Owner Change Order

Change Order Number: 003

City of Norman - North Base Complex Phase 1
1310-1380 DA Vinci Street
Norman, Oklahoma 73069

The Contract is hereby revised by the following items:

DRAWING TITLE
ENLARGED PLUMBING PLANS

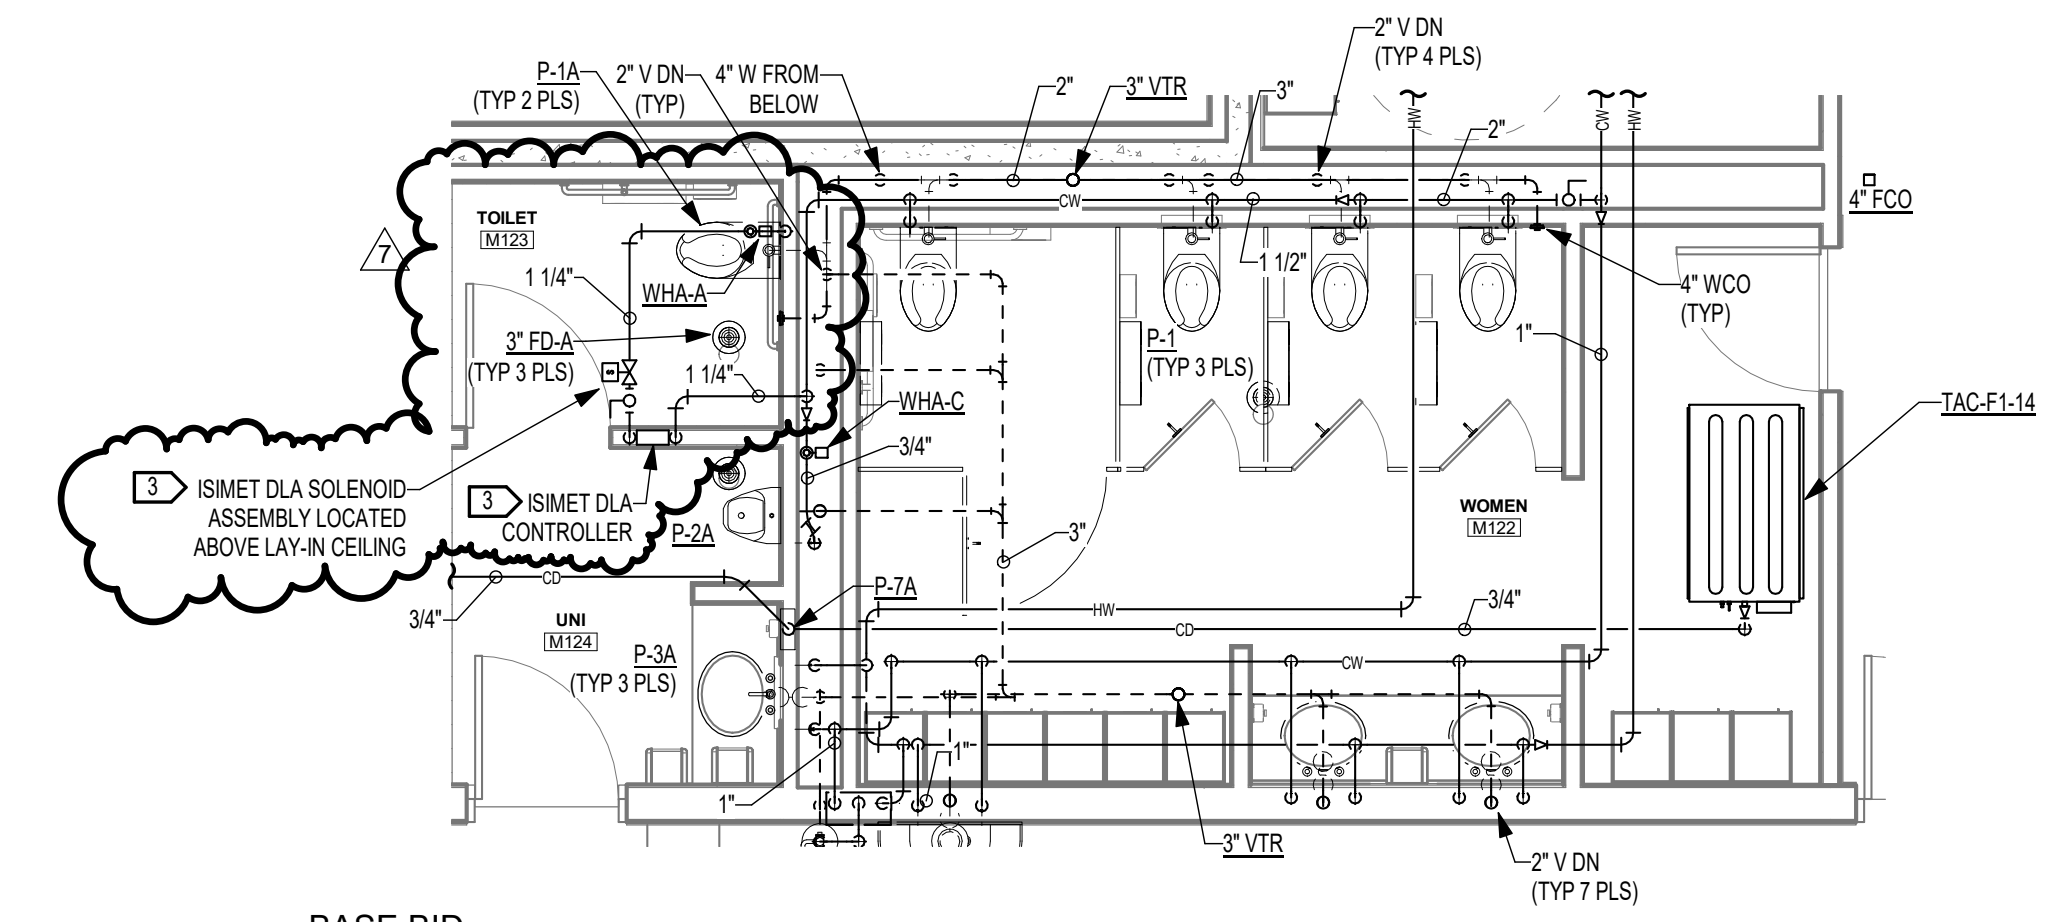
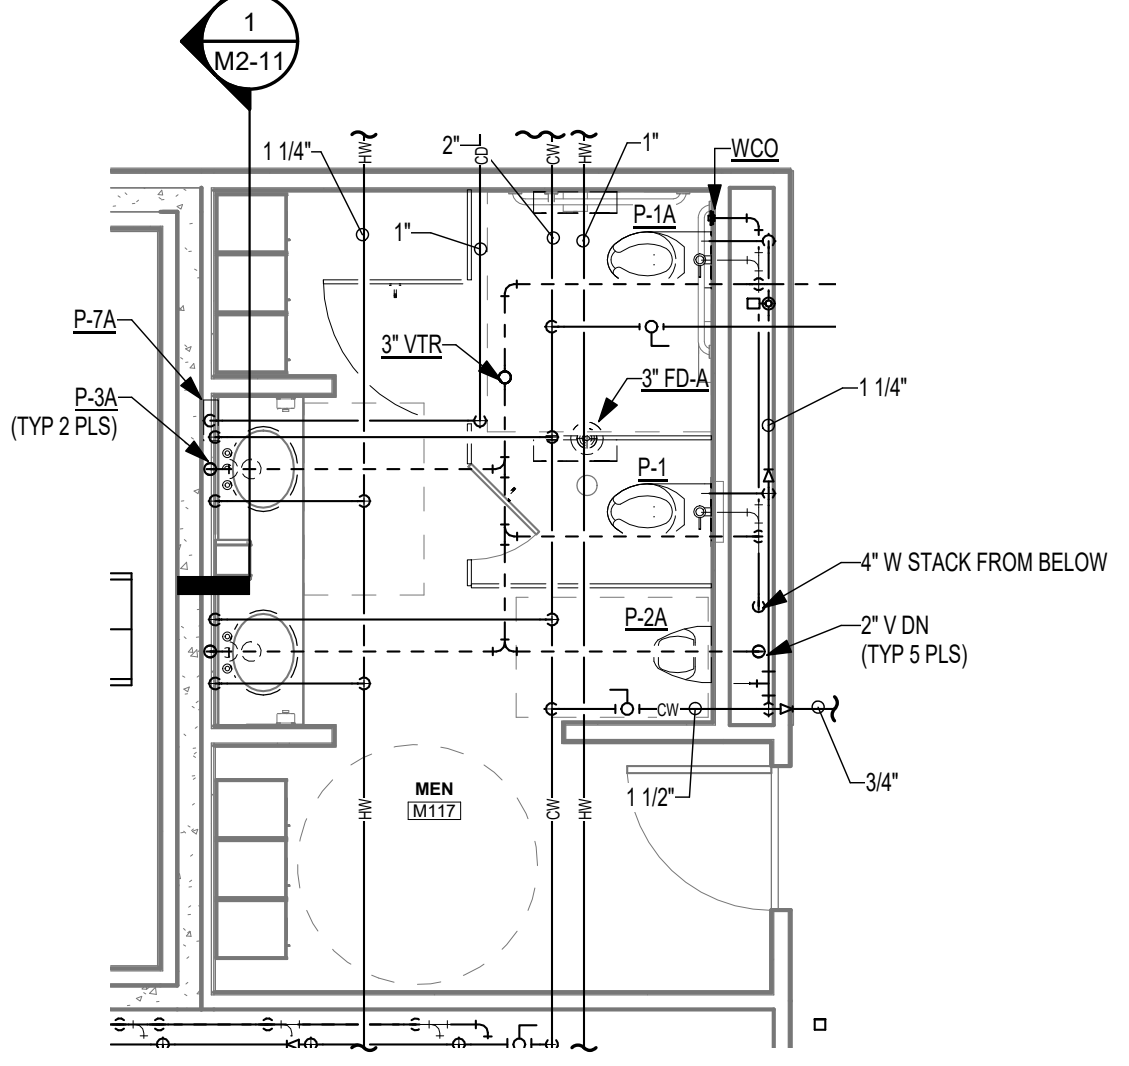
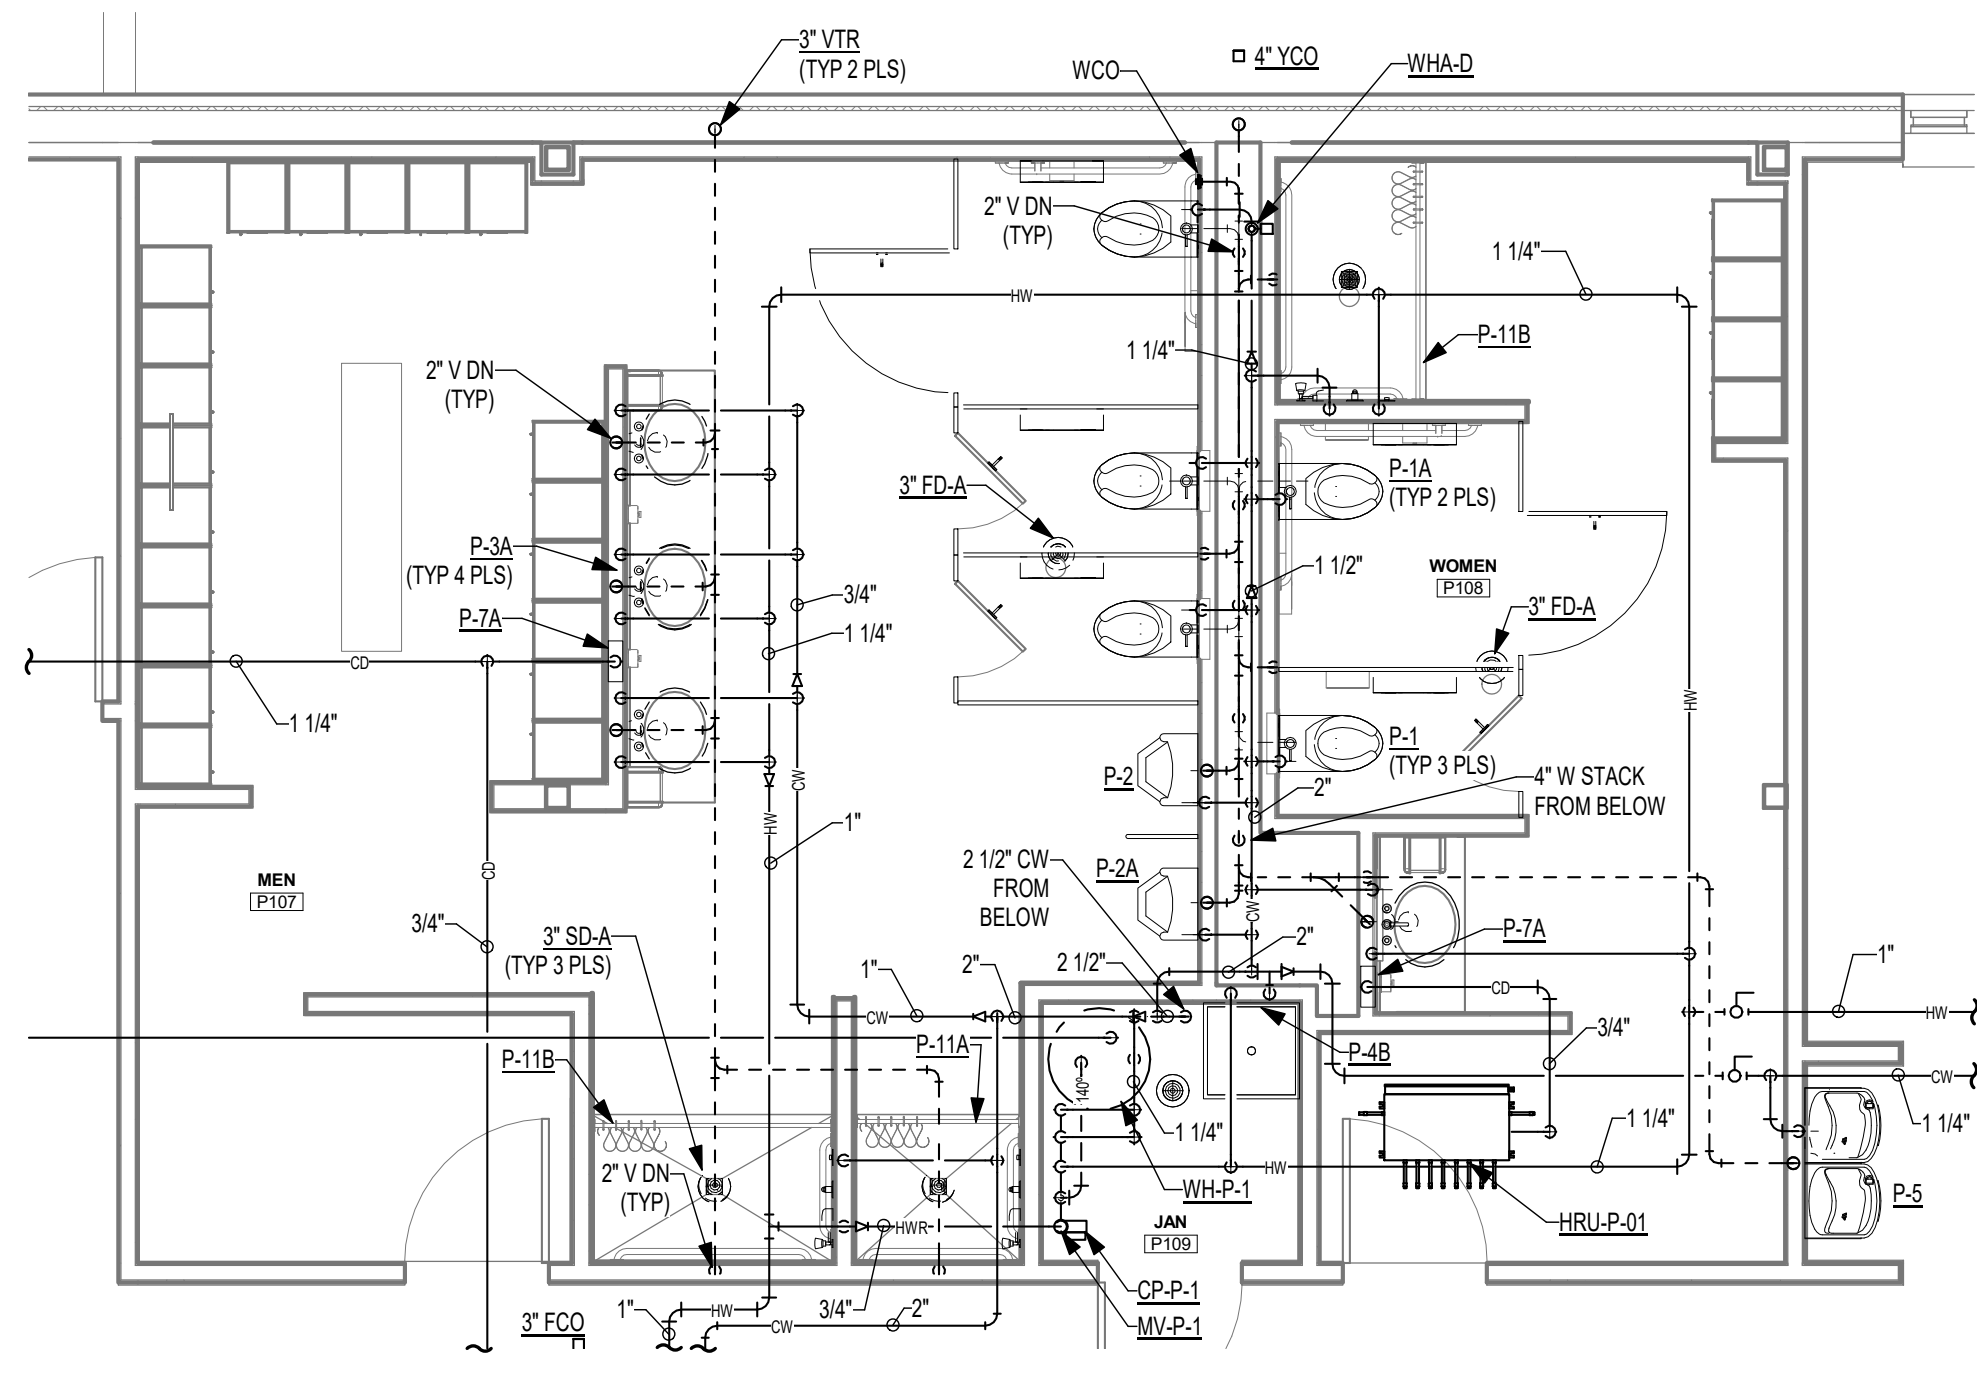
Revision 7 plumbing changes including addition of solenoid valve and switch for water line in restroom. Modifications to water lines included. Please see breakout (attached).

- ROUTE CONDENSATE DRAIN TO ED-8. PROVIDE SECURE INDIRECT CONNECTION.
- PROVIDE ALEMITE MODEL #K3010 FLUID MANAGEMENT SYSTEM CONTROLLER WITH PRINTER OR PRIOR APPROVED ALTERNATE.
- PROVIDE ISMET DLA SERIES WATER CONTROLLER FOR DRUG TESTING LAB FOR SINGLE RESTROOM USE. CONTROLLER TO BE MOUNTED TO WALL FACING ROOM UNI #M124. CONTROLLER TO BE MOUNTED 48" AFF. PROVIDE FACTORY SOLENOID VALVE ASSEMBLY, LOCATED ABOVE LAY-IN CEILING IN ROOM TOILET #M123.
